County of Fairfax, Virginia

STAFF REPORT ADDENDUM III

SPECIAL EXCEPTION APPLICATION SE 2008-PR-021

PROPOSAL: To permit a child care center and nursery school with a maximum enrollment of 150 students.

JANUARY 3, 2011	DES.	JK	DWN	RMC
DECEMBER 3, 2010				
NOVEMBER 5, 2010				
SEPTEMBER 23, 2010				
JULY 23, 2010				
DATE:	JULY 9, 2010			
SCALE:	1"=25'			
PROJECT/FILE NO.	V7229A			
SHEET NO.	3

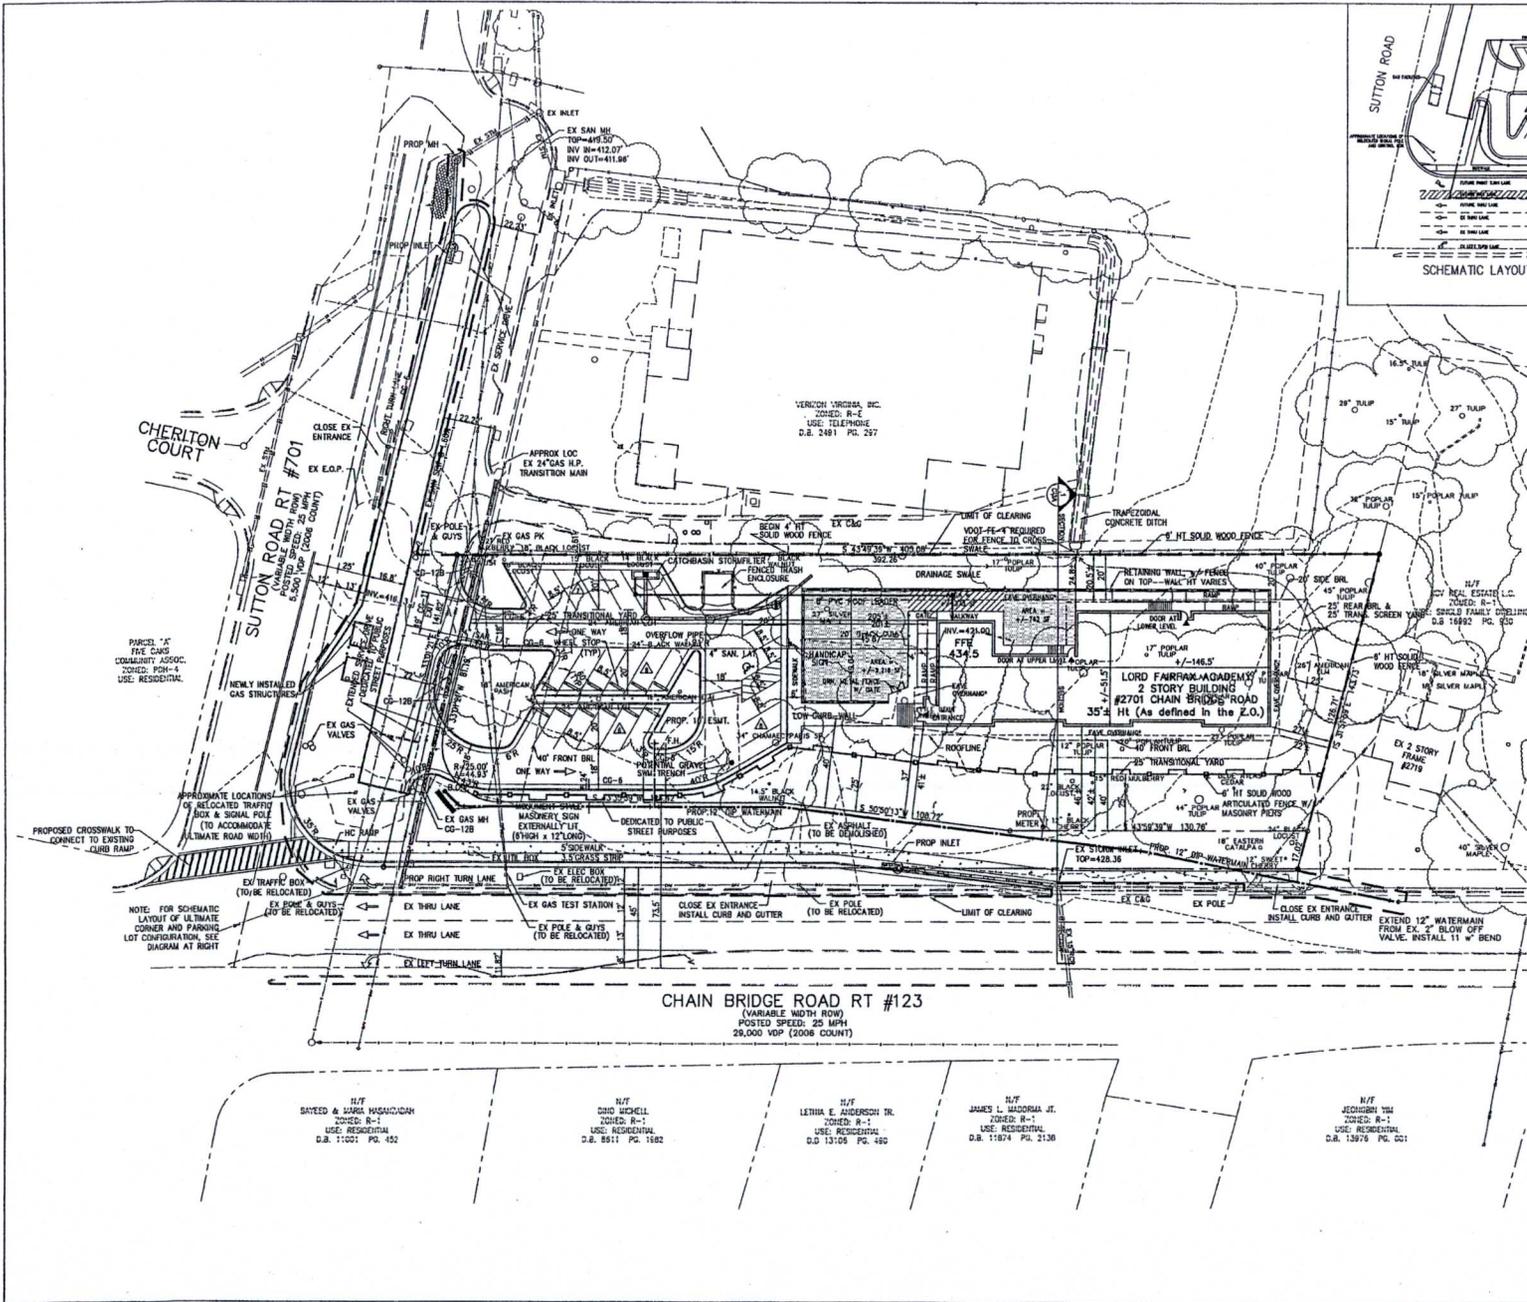
An alternate schematic layout is also depicted on Sheet 3 for the ultimate Route 123 (Chain Bridge Road) configuration. It shows one access point to the site serving as both an entrance and exit to Sutton Road. The proposed access point would be located approximately 60 feet from the intersection of Sutton Road and Chain Bridge Road.

- The applicant's sketch of potential, not yet planned, improvements to Sutton Road, which show the proposed right turn lane modified to a through-lane to accommodate a future four-lane undivided roadway contradicts staff's belief that a four-lane median divided roadway would be warranted.

- the need to reduce the proposed number of children;
- the need for the proposed building to be set farther back from the Chain Bridge Road frontage to provide more space for buffering;
- the need to relocate the play area;
- the need for a reduction in the size of the surface parking lot; and
- the need for the construction of a right-turn lane on Chain Bridge Road.
